Addendum 47: Regulation No. 48

Revision 6 – Amendment 11

06 series of amendments - Date of entry into force: 18 November 2012

Uniform provisions concerning the approval of vehicles with regard to the installation of lighting and light-signalling devices

Model A

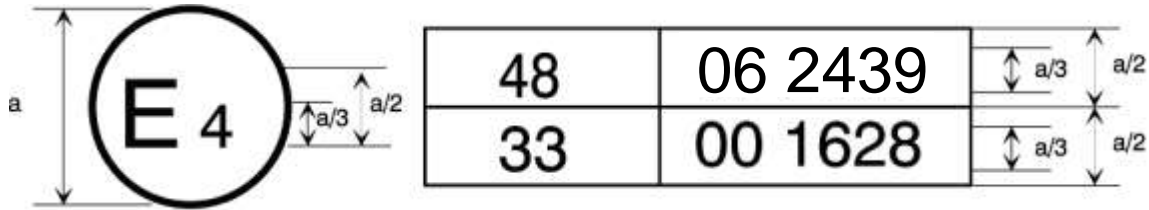
Annex 2, amend to read:

The above ... Regulation No. 48 as amended by the 06 series of amendments. The approval number indicates that the approval was granted in accordance with the requirements of Regulation No. 48 as amended by the 06 series of amendments.
